Prairie Island Nuclear Generating Plant

Spent Fuel Pool Criticality Technical Specification Changes

Round 2 Request for Additional Information

Public Meeting
Rockville, MD
March 9, 2017

Model of Eccentricity Changed

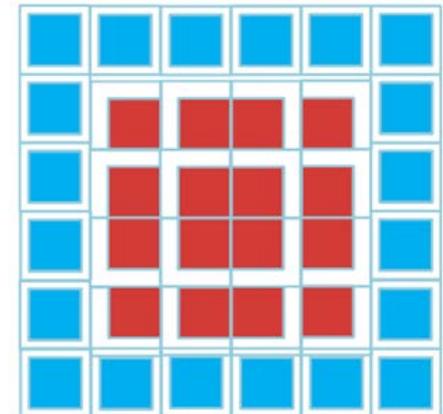
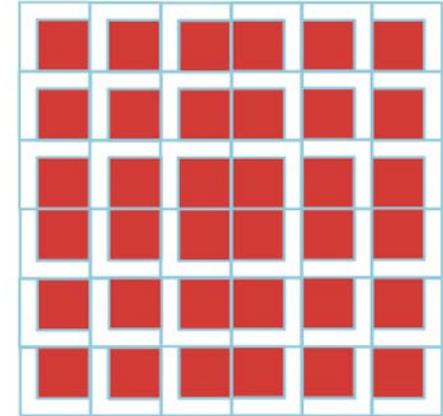
- LAR: Treated as uncertainty (consistent licensing basis and NRC approved analysis)
- RAI requires eccentric positioning as a bias, based on:
 - ◆ NEI agreement on draft guidance NEI 12-16
 - ◆ Large reactivity effect on PINGP
- No basis established that adverse eccentricity was probable
- No statistical basis for treating the adverse eccentricity as a bias
- Little precedent and no approved topical methodology for modeling eccentricity as a bias

- Analysis of Record, LAR assumed 6x6 reflected

Analysis for Round 2 RAI Reply

- Assumes 4x4 (16) assemblies are adversely eccentric
 - ◆ Very improbable statistically (later)
- When reflected, two concentric rows decouple the eccentric array
- When reflected at boundary, the model represents >>16 eccentric bundles in SFP

Figure 7-4: Grid Growth Database Data for Longitudinally Stamped ZIRLO[®] Grids

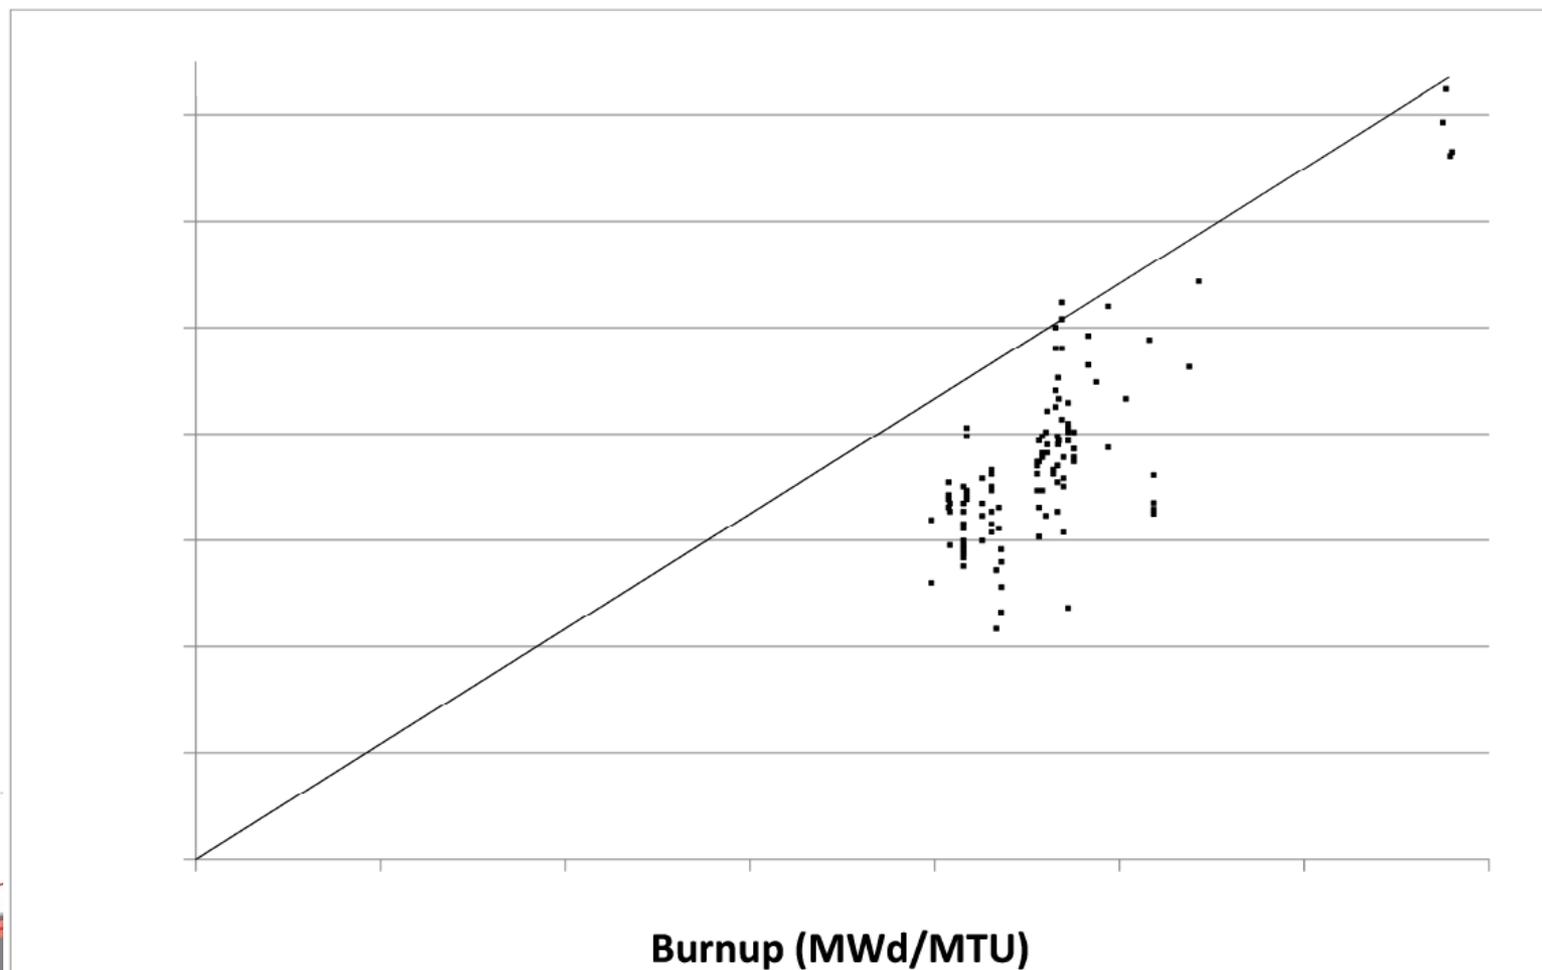
- LAR: Considered pin pitch tolerance, not grid growth
- ISG: No consideration of grid growth
- RAI requests consideration of grid growth, based on:
 - ◆ General concern that grids expand during irradiation
 - ◆ Issue identified in NEI 12-16 guidance development
 - ◆ NRC Staff study of uniform pitch changes cause 1000 pcm increase

- Measured growth data from longitudinally stamped ZIRLO® grids
- 122 different measurements of growth at varying burnups
- Growth is scaled to 14x14 fuel grid size

- Excluded single data point, not median
- Assumed uniform pin pitch growth
- Assumed all grids grow at max growth rate
 - ◆ Ignores axial variation in burnup
 - ◆ Ignores Inconel top grid at location which drives reactivity most
